Product Change Notification / SYST-140DIZ453

ERRATA - KSZ9131MNX Silicon Errata and Data Sheet Clarification

Silicon Errata and Data Sheet Clarification

FIGURE 1: TOP MARKING DATE CODE INDICATION

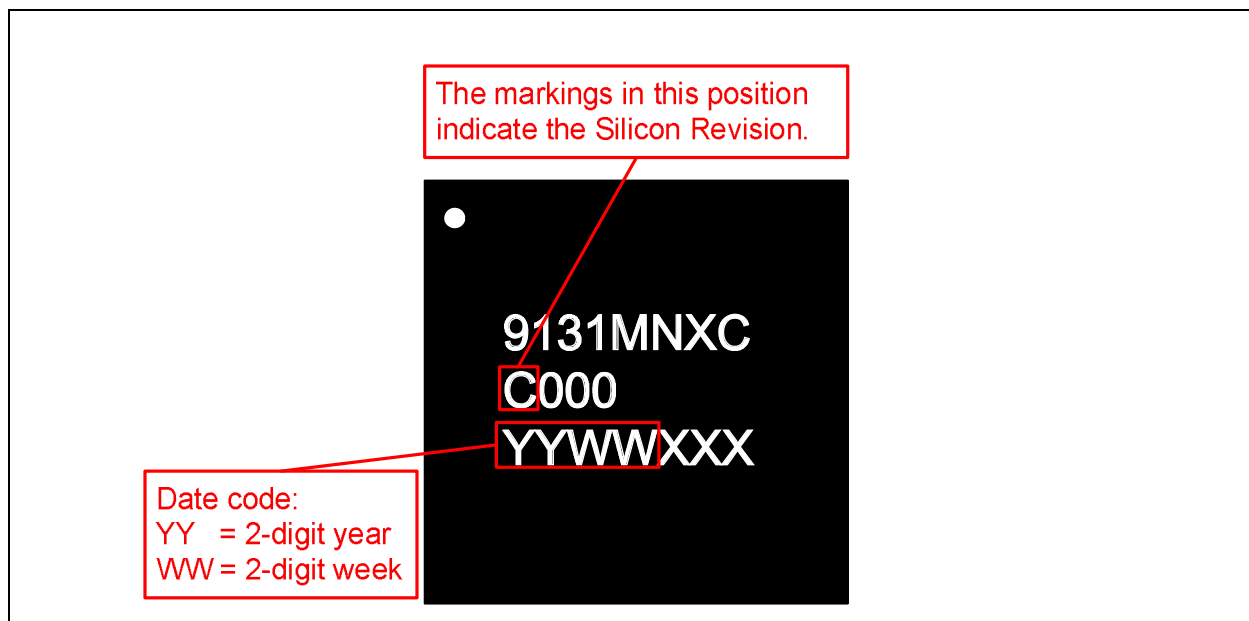
Revision Level & Date	Section/Figure/Entry	Correction
DS80000997B (02-18-22)	Table 1 , Table 2 , and Figure 1	Changed the silicon revision marking from "C0" to "C."
DS80000997A (02-14-22)	All	Initial release
